# Work Order ID 85985

Item Name: Crosstube Turning Detail

<b>DART AEROSPACE LTD</b>	<b>Work Order:</b>	85985
<b>Description:</b> Crosstube Assembly (205/212/412 High Fwd)	<b>Part Number:</b>	D212-664-141
<b>Inspection Dwg:</b> D212-664-141 <b>Rev:</b> D		Page 1 of 2

DRAWING NO. D212-664-141	TITLE XTUBE ASSY (205/212/412 HI FWD)	REV. D	DART AEROSPACE LTD ENGINEERING ORDER		D.E.O. NO. D212-664-141-D-1	SHEET NO. SHEET 1 OF 2	SCALE NTS
DRAWN	CHECKED	MFG. APPR.	APPROVED	DE APPR.			
DATE 11.04.07	DATE 11.04.11	DATE 11.04.12	DATE 11/04/12	DATE 11.04.12

**D212-664-141/-141B  
ASSEMBLY DETAIL**

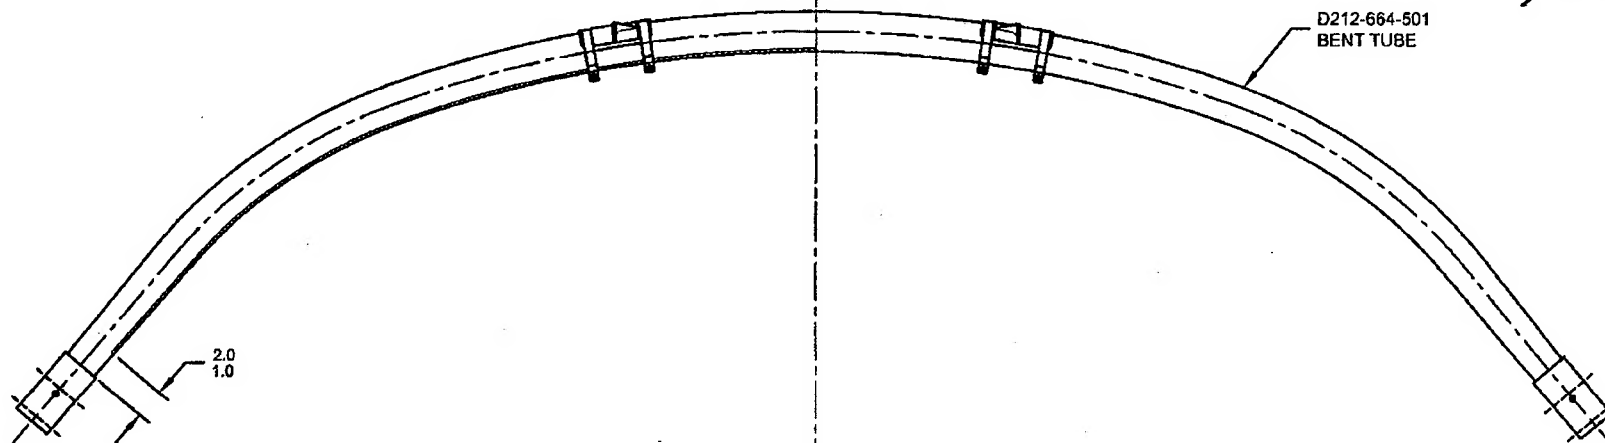
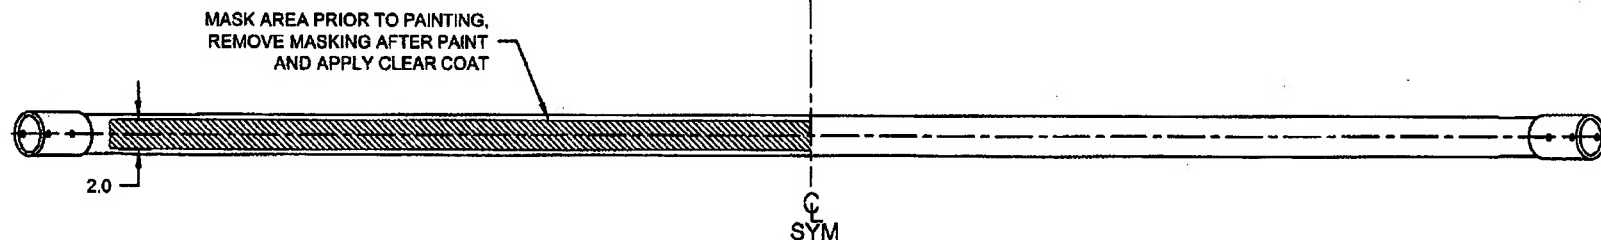
**PURPOSE:**  
ADD AN INSPECTION WINDOW TO UNDERSIDE OF CROSSTUBE.

- 2) FINISH: CHEMICAL CONVERSION COAT PER DART QSI 005 4.1  
PRIME INSIDE AND OUTSIDE PER DART QSI 005 4.2  
MASK UNDERSIDE OF CROSSTUBE AS SHOWN (HATCHED AREA) AND  
PAINT OUTSIDE PER DART QSI 005 4.2  
REMOVE MASKING AND APPLY CLEAR COAT

- 2) FINISH: CHEMICAL CONVERSION COAT PER DART QSI 005 4.1  
PRIME INSIDE AND OUTSIDE PER DART QSI 005 4.2  
PAINT OUTSIDE PER DART QSI 005 4.2
